All Bidders**Amendment –II**

Project: Supply, Installation, Testing & Commissioning of CSSD for Hospital Block, All India Institute of Medical Sciences (AIIMS), Raebareli.

IFB No. HSCC/SES/CSSD/AIIMS/Raebareli/2019 Dated 22.11.2019

BASEMENT FLOOR PLAN

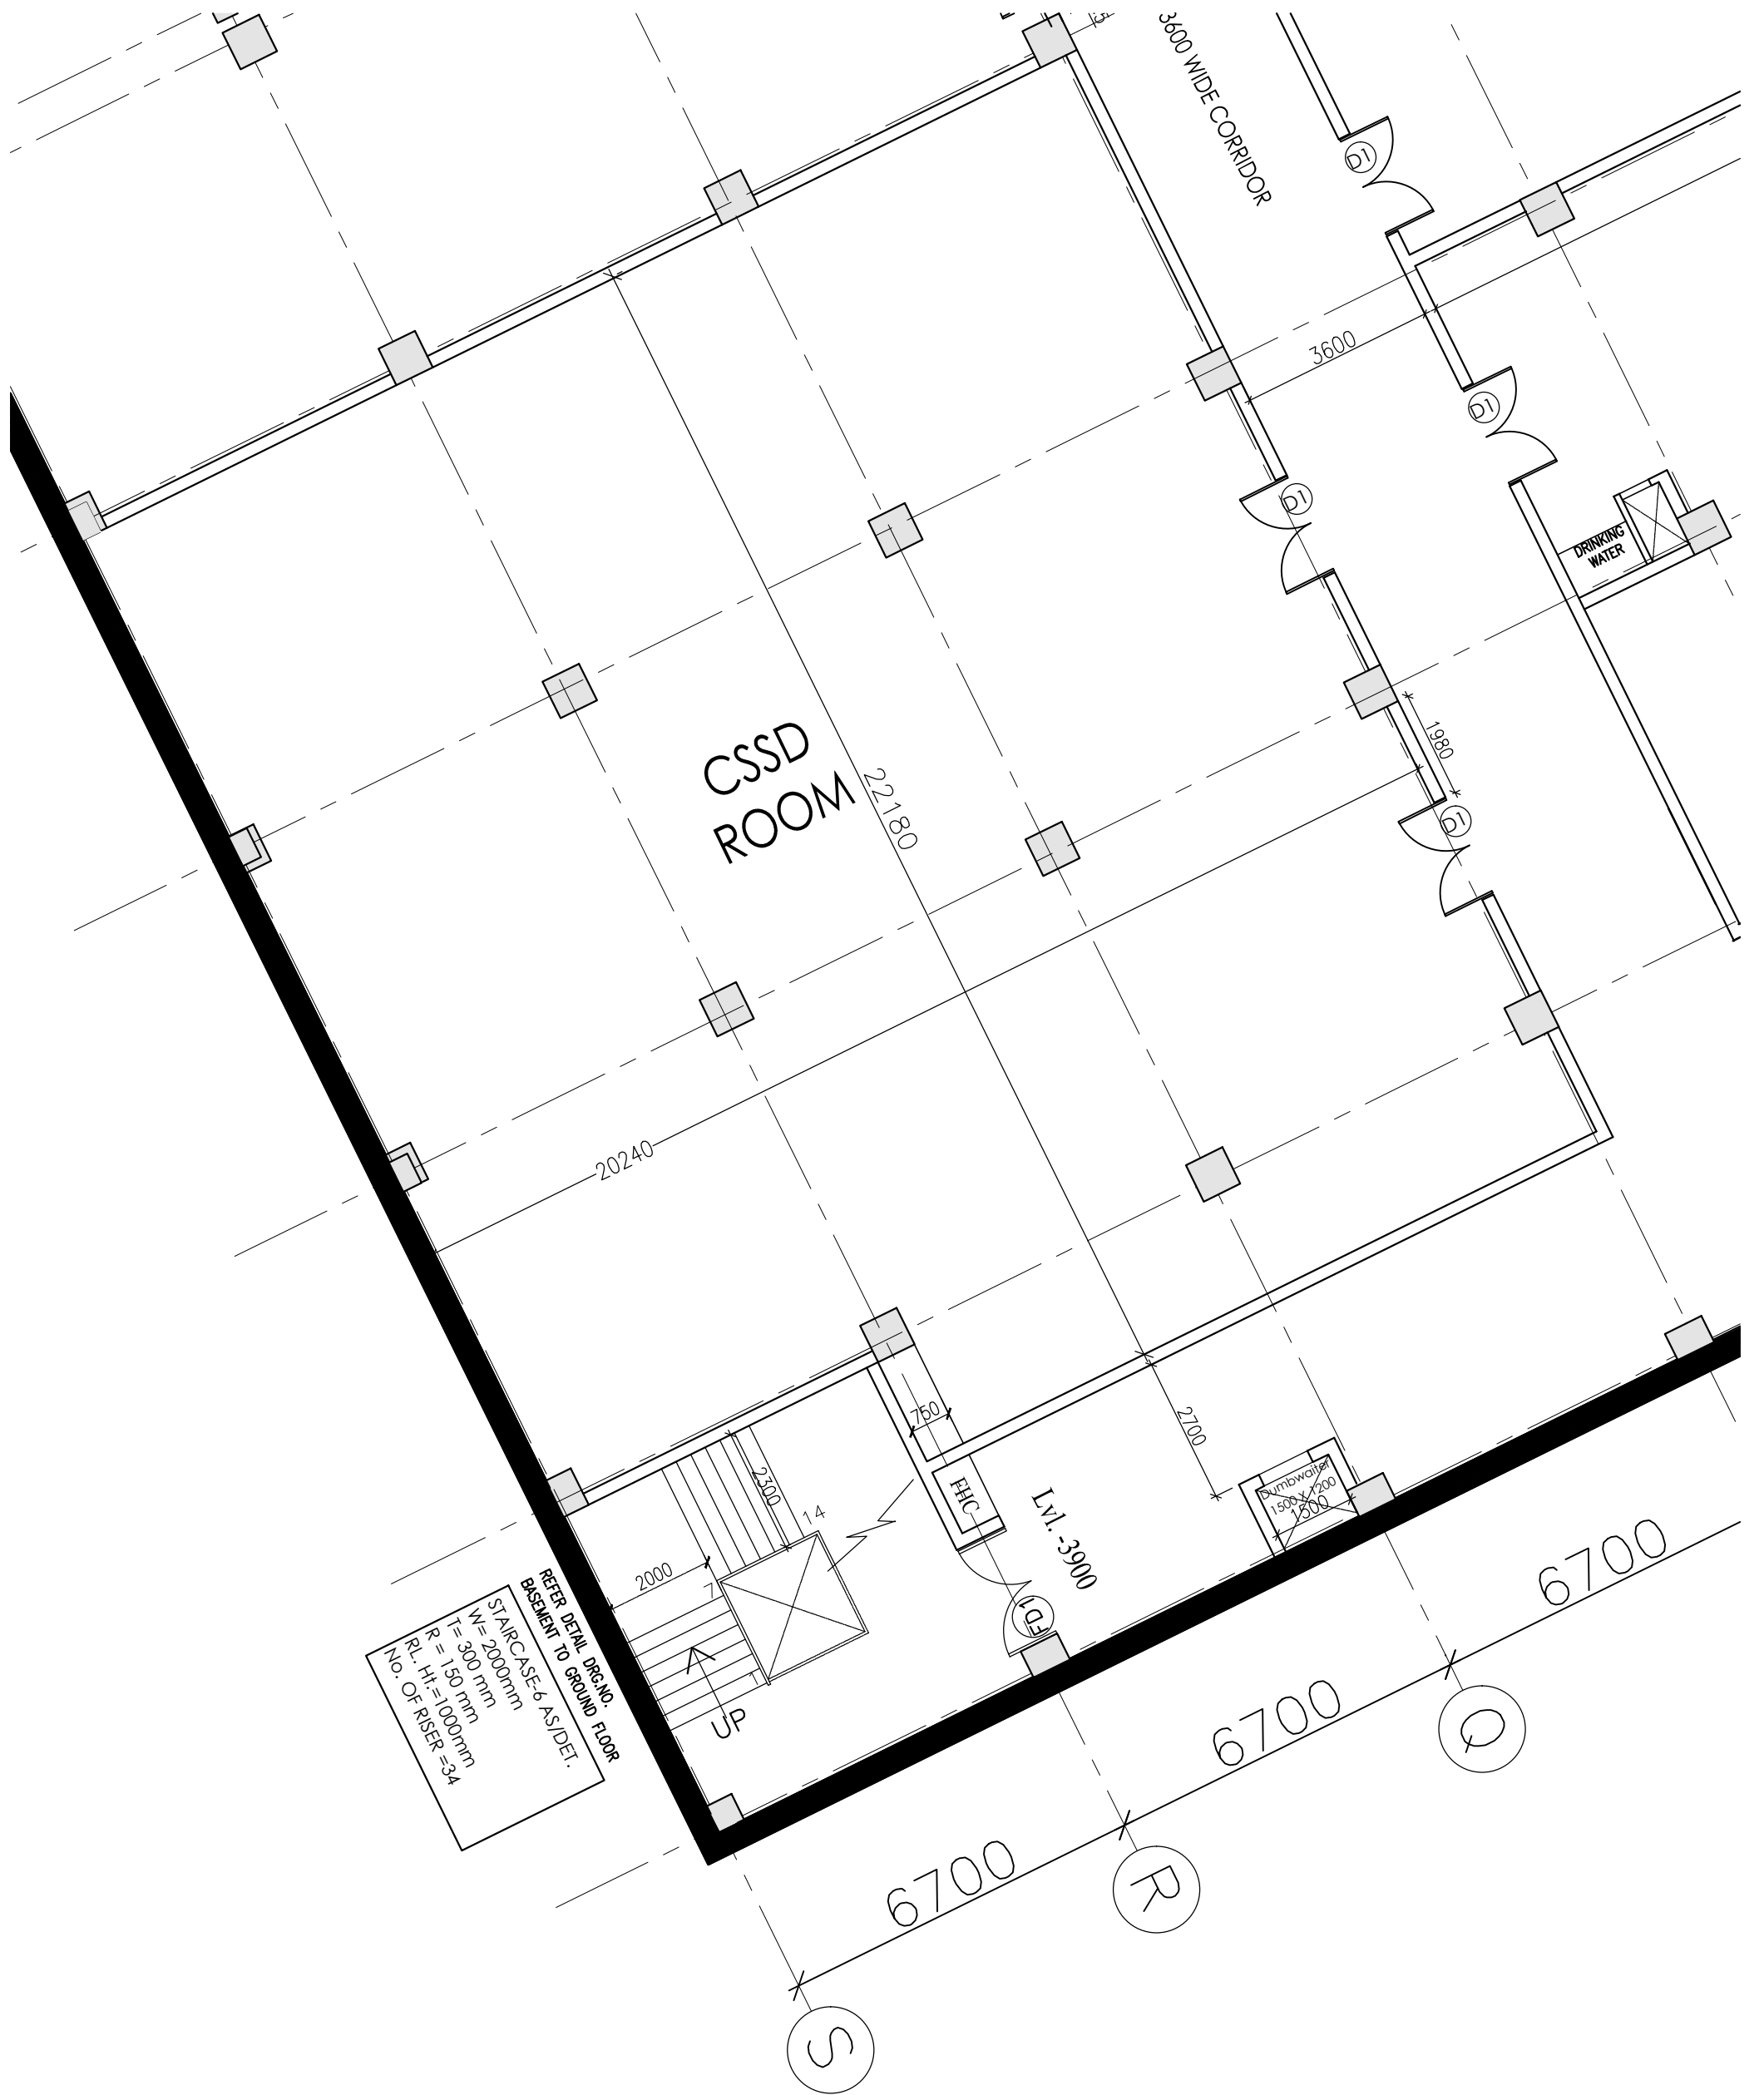
46	<p>Furniture Items All CSSD Furniture items should be accepted with ±10% deviations.</p> <p>Kindly amend the same.</p>	Tender terms & conditions prevail
47	<p>CSSD Layout We request you to kindly provide us Layout also for better understanding of turnkey work.</p>	Enclosed
